# CITY OF COLORADO SPRINGS PUBLIC WORKS DEPARTMENT

PRELIMINARY (30%) PLANS OF PROPOSED  
**US HIGHWAY 24 & PETERSON BLVD/RD ROUNDABOUTS**  
DECEMBER 20, 2023

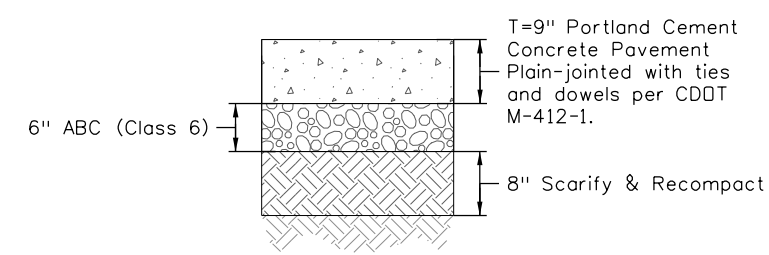
Reference City detail for RAB (and other) C&G?
